**PLAN COMMISSION PC #21-022**  
**BMO Bank SUP**  
**630 W Northwest Highway**  
**Round 2**

***CivWorks Response in Bold Italics dated 01-31-2022***

# Planning & Community Development Dept. Review

Project: BMO Bank  
630 W Northwest Highway

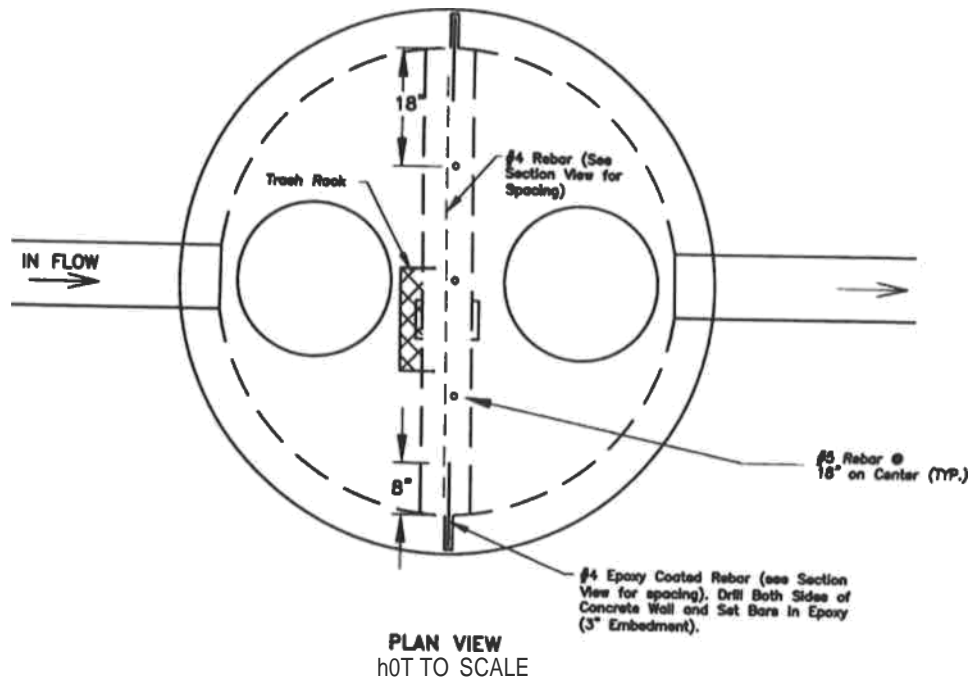
***The requested additional truck turn exhibit is enclosed for review.***
33. The petitioner's response to comment no. 22 is noted. In reference to the picture below, the adjacent concrete parking lot is flush with the existing asphalt adjacent to the building. A section of the curb will be adjacent to the edge of the concrete parking lot will not be at the same elevation. Although the drainage of the adjacent parking lot is not impacted, the use of the adjacent lot is of concern, particularly if snow is covering the curb and a vehicle is unaware that there is an elevation difference and could drive over the curb. Modifications may be needed for this area to ensure the neighboring property is not negatively impacted. The petitioner should consider coordinating with the adjacent parcel and constructing a curb adjacent to the concrete parking lot.

**Note that the grading in this area has been adjusted so that the pavement elevation on our site matches the pavement elevation on the adjoining parcel. This will create a situation where the curb will be raised and act as a barrier between the two properties. There is no longer a danger of someone not realizing there is an elevation difference and driving over the curb.**

## OUTLET CONTROL STRUCTURE

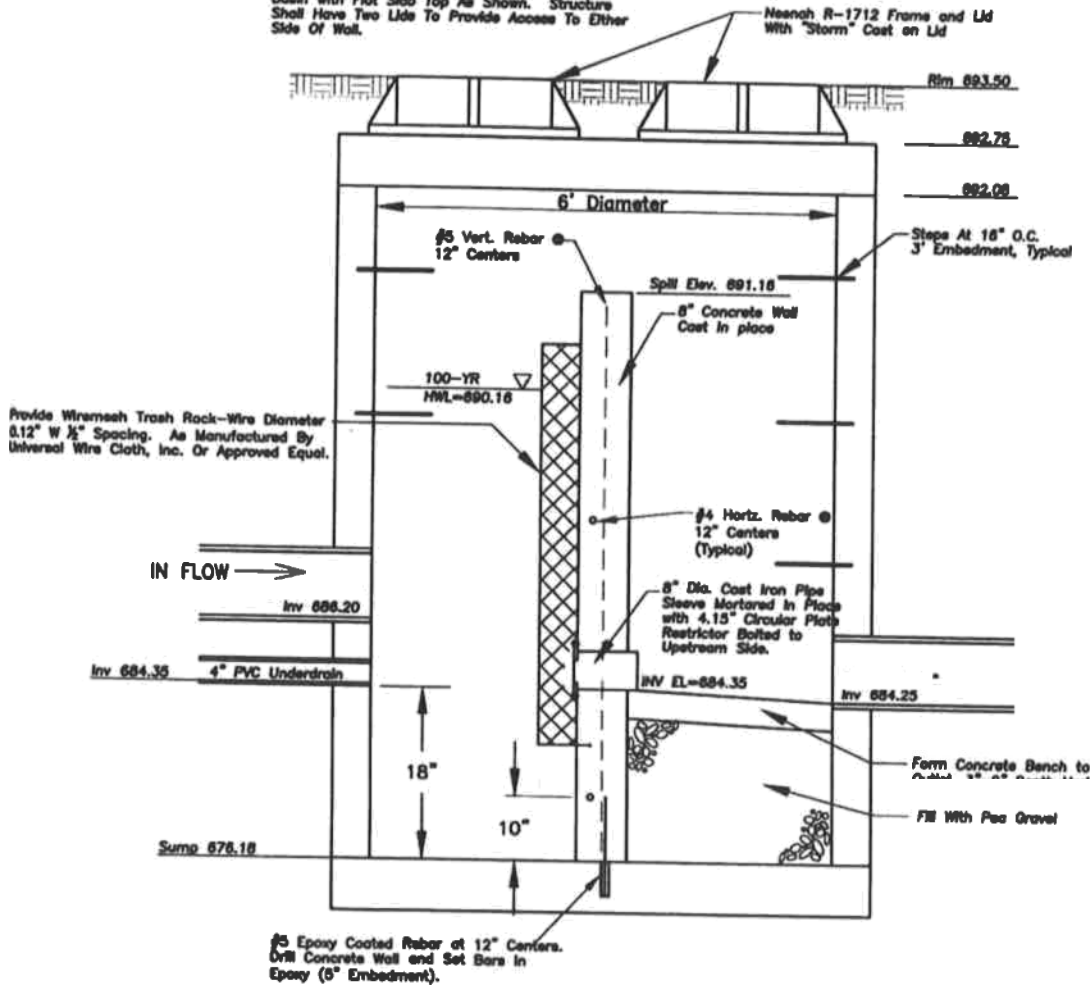
29. The petitioner's response to comment nos. 11, 12, 15, 16, 17, 19, 21, 24, and 28 are acceptable.  
***So noted.***
30. The petitioner's response to comment nos. 13 and 14 is noted. The proposed methodology only captures 1,287 CF of the required 10,455 CF of storage. The Village is aware of the constraints of the site; however, the petitioner shall consider other alternatives for underground detention to provide additional storage, for example a shallow box culvert. This area is tributary to the combined sewer area, the Village is sensitive to storm water entering a combined system. The restrictor detail is not acceptable. Attached is an outlet control structure that would be acceptable to the Village.

Note:  
Structure Shall Be Modified 6' Diameter Catch Basin with Flat Slab Top As Shown. Structure Shall Have Two Lids To Provide Access To Either Side Of Wall.

***So noted. The storm sewer and detention design is still being coordinated with the Village engineering department and will be finalized during the permit stage.***
